# D-PLCA Comment #46 Accommodation for Static Node IDs greater than Seven

IEEE 802.3da Interim May 2025

# Comment #46 Problem

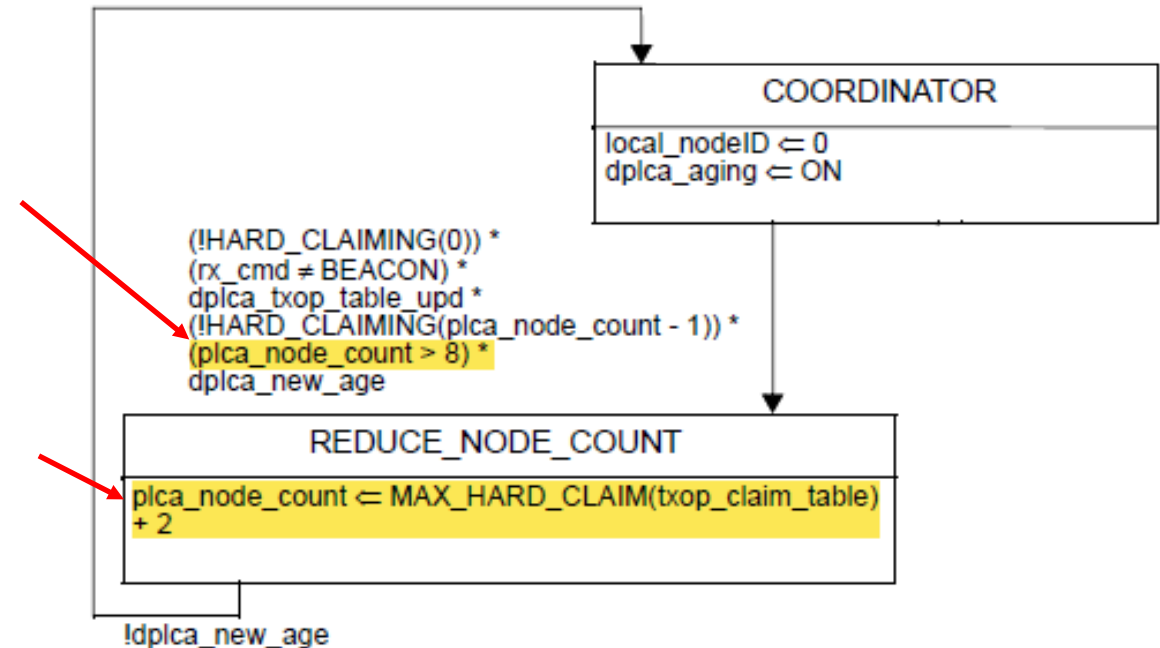
- **What happens to nodes that are statically assigned `localNodeID > 7`?**
  - Coordinator may *never* expand `plca_node_count` large enough to include the node.
    - Only if a D-PLCA node claims TOs up to the statically assigned node IDs
    - Static nodes may therefore *never* receive a TO on which to commit
- **Existing PLCA systems may contain many more statically assigned nodes**
  - Some up to 40 nodes!

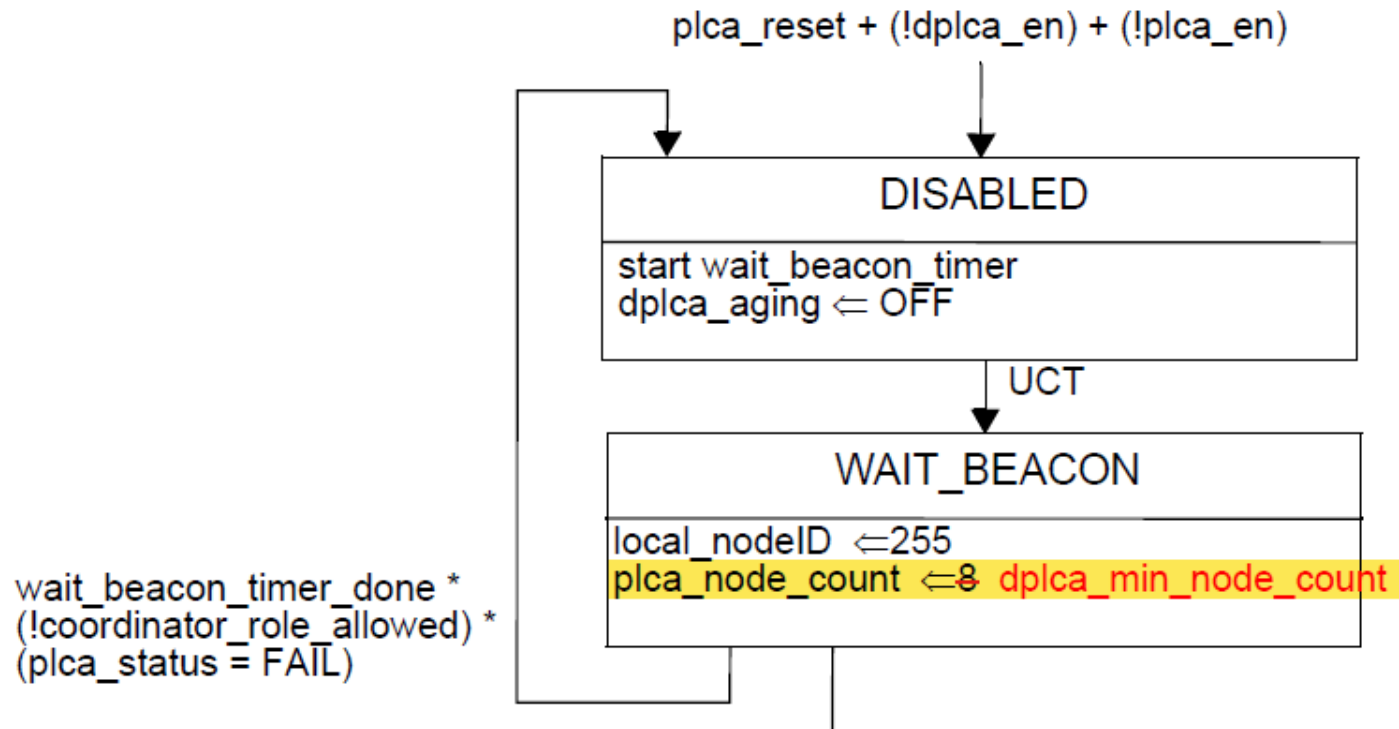
- **New D-PLCA variable**

`dplca_min_node_count`

Minimum number of PLCA nodes on the mixing segment receiving transmit opportunities before D-PLCA coordinator generates a new BEACON. The D-PLCA coordinator will reduce the number of transmit opportunities below this value. All PLCA nodes operating without D-PLCA enabled should have a statically assigned PLCA `local_nodeID` below this value. Nodes without D-PLCA enabled and set with a `local_nodeID` greater than `dplca_min_node_count-1` may never get a transmit opportunity allocated.

Values: integer number from 1 to 255

Default: 8

## REDUCE\_NODE\_COUNT

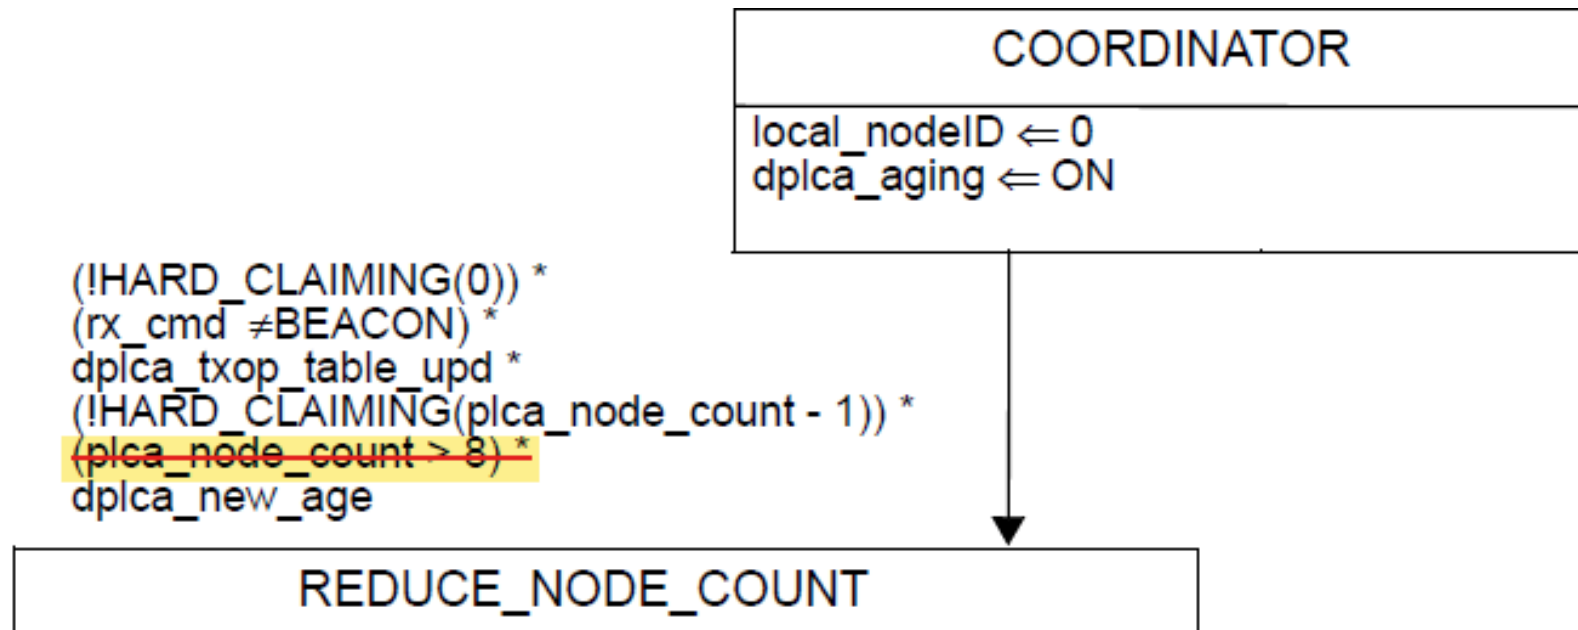
- **Update action in REDUCE\_NODE\_COUNT state**
  - Test highest claimed TO and limit reduction of plca\_node\_count to the desired minimum node count
  - Prevents corner case of assigning plca\_node\_count below the minimum

```
IF (MAX_HARD_CLAIM(txop_claim_table) + 2) < dplca_min_node_count) THEN
    plca_node_count ← dplca_min_node_count
ELSE
    plca_node_count ← MAX_HARD_CLAIM(txop_claim_table) + 2
END
```

- Update Figure 148-8 (P79) as follows:

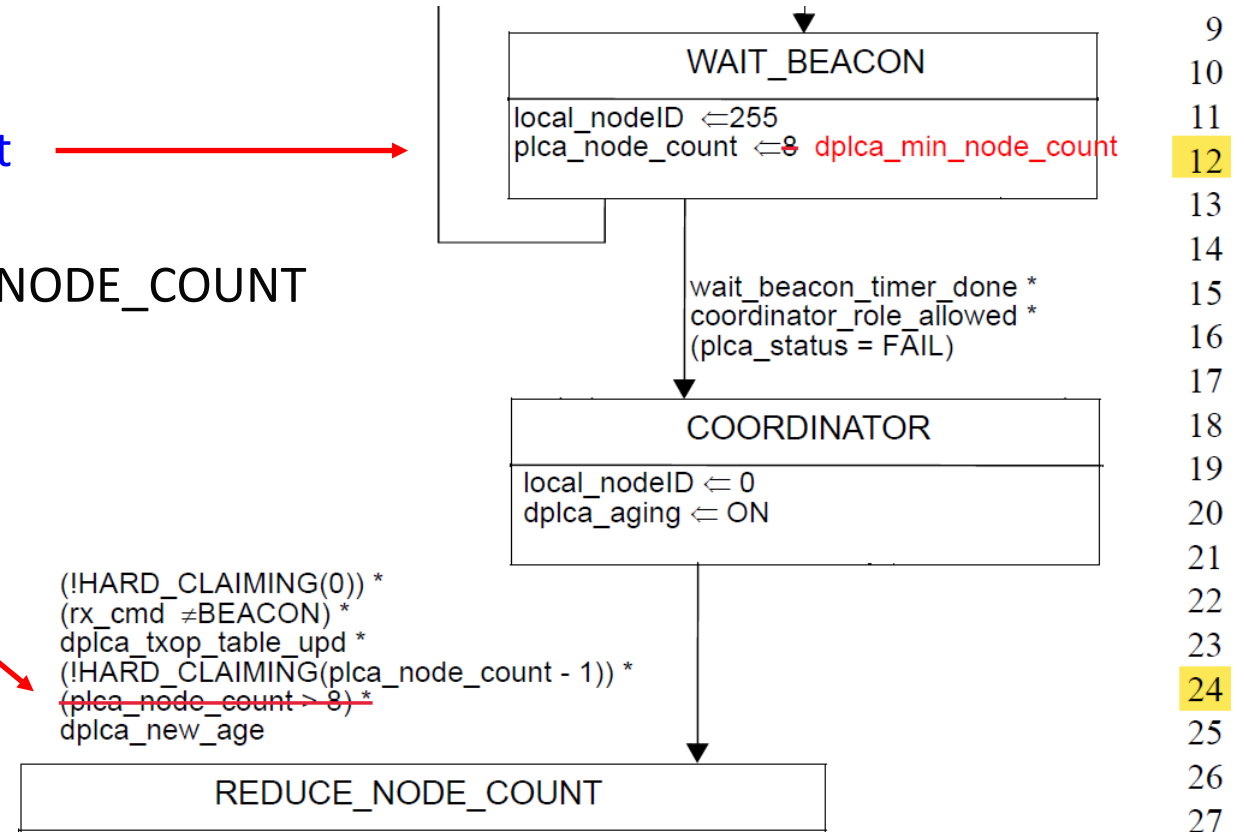
L12: In state WAIT\_BEACON

L24: In transition from COORDINATOR to REDUCE\_NODE\_COUNT

Change:  $plca\_node\_count \Leftarrow 8$

To:  $plca\_node\_count \Leftarrow dplca\_min\_node\_count$  →

Delete:  ~~$(plca\_node\_count > 8) *$~~  →
